SERVICE LETTER 00034

Subject: Optional B&C Voltage Regulator Installation

Affected Models: RV-12 and RV-12iS with Rotax 912ULS engines

Required Action: Optional installation of EA-XB100-1

FIGURE 1: BOND DUCT TO COWLING

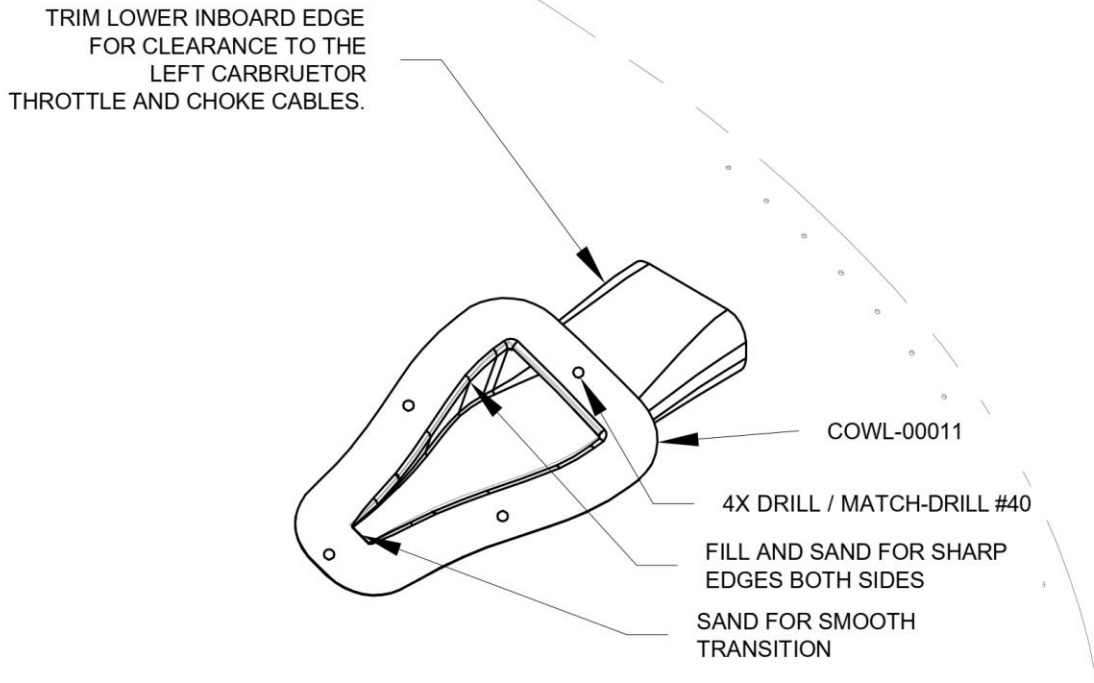
Step 6: Bond the COWL-00011 to the upper cowling using an epoxy floc mixture. A few #40 holes and wax coated clecos work well to hold position and clamp force until the epoxy is cured enough to be "rubbery". See Figure 1.

Step 7: Fill the edges of the COWL-00011 to cowl interface to make a nearly sharp corner along the sides as indicated in Figure 1. Fill and sand to provide a smooth transition from the cowl surface to the duct. Finish and paint as desired.

FIGURE 2: REMOVE WIRES FROM CONNECTOR

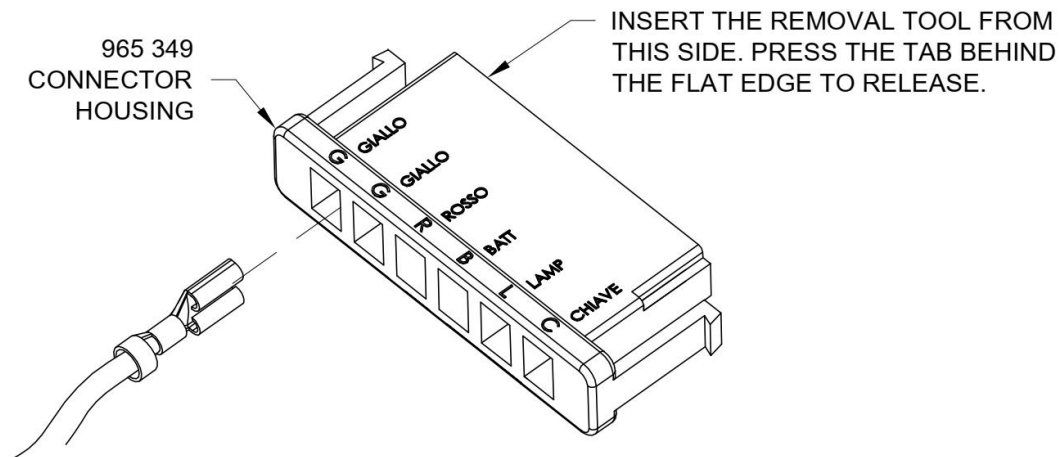
Step 9: Remove the pins from the Ducati regulator connector. See Figure 2. The connector will not be reused in this installation.

FIGURE 3: DUCATI UPGRADE WIRE CONNECTIONS

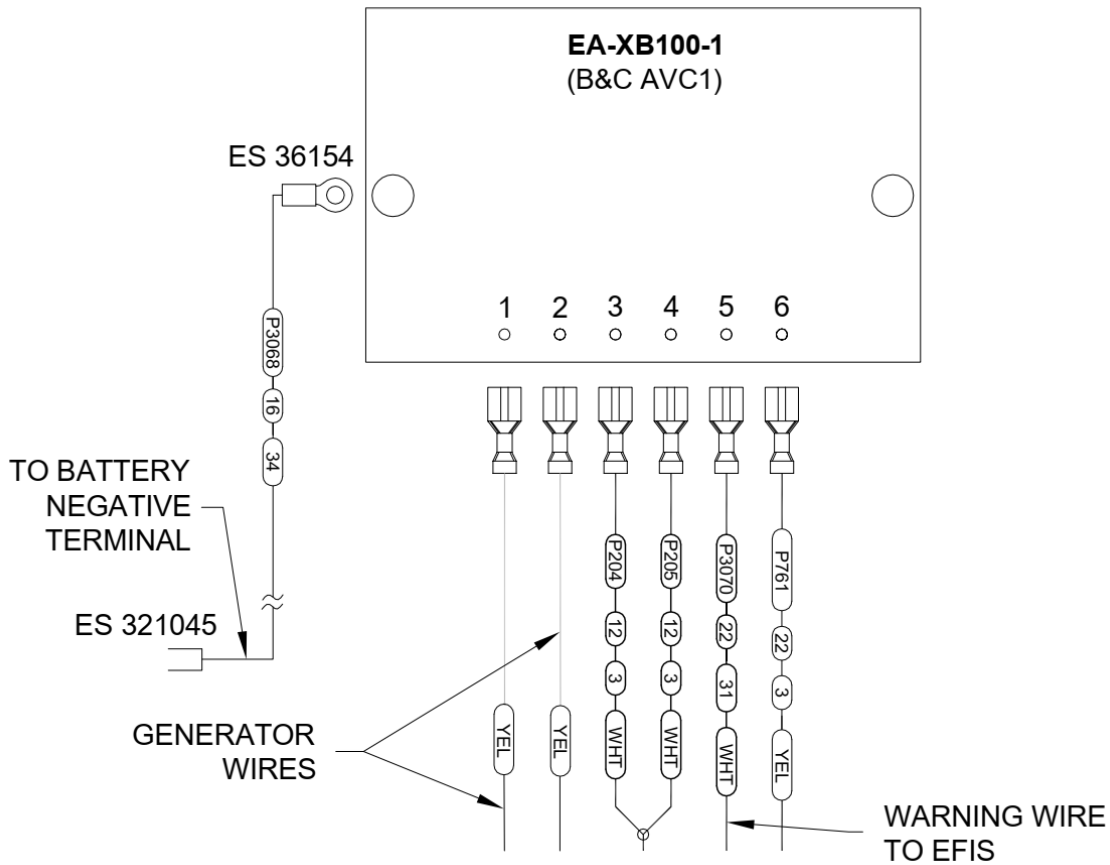
Step 13: Fabricate the WH-P3068 wire shown in Figure 3 out of 16 AWG (WHT) wire using the wire ends and length shown.

Step 14: Connect the electrical wires to the regulator as shown in Figure 3.

FIGURE 4: ROUTING WH-P3068

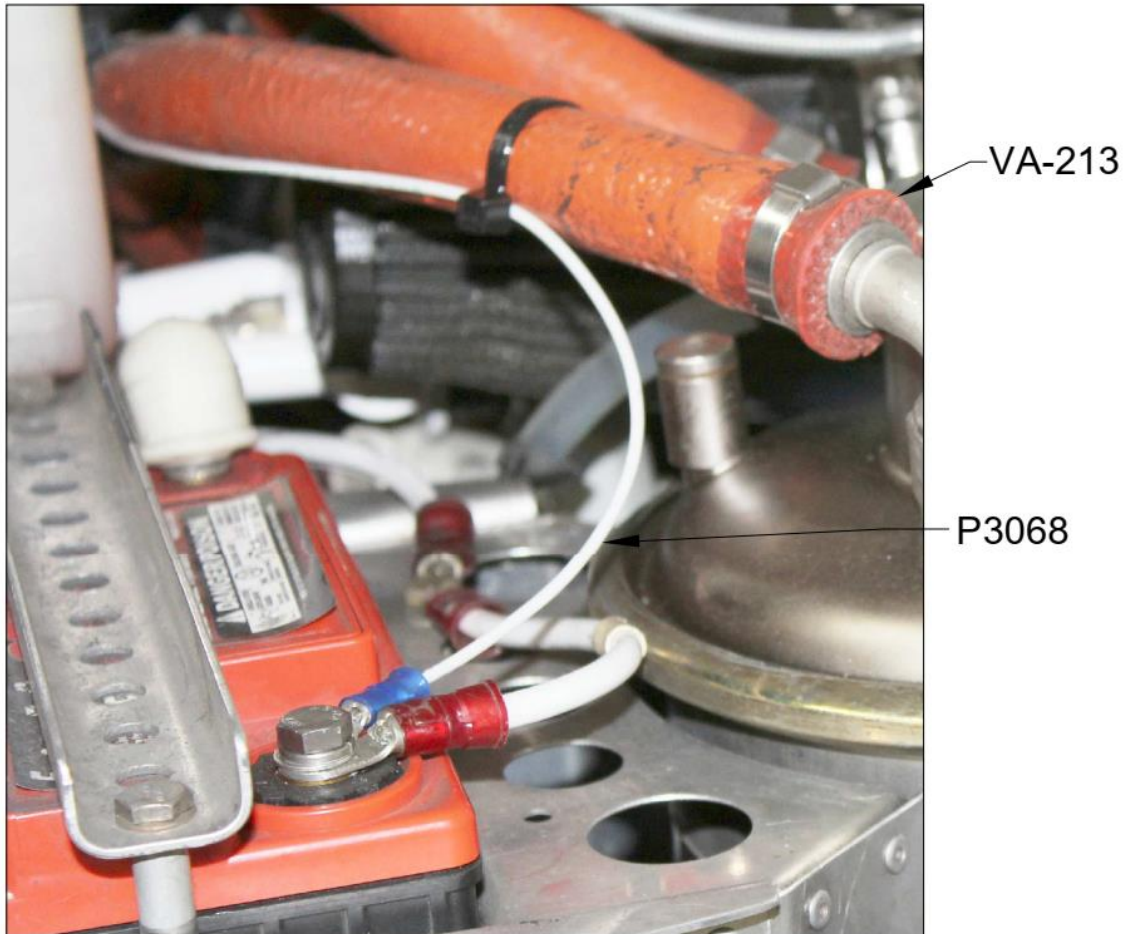
Step 16: Route the WH-P3068 wire with the wire bundle and then along the VA-213 Oil Supply Hose towards the battery. Connect the ring terminal on WH-P3068 to the minus terminal of the battery See Figure 4. Tie-wrap the wires as necessary for support.
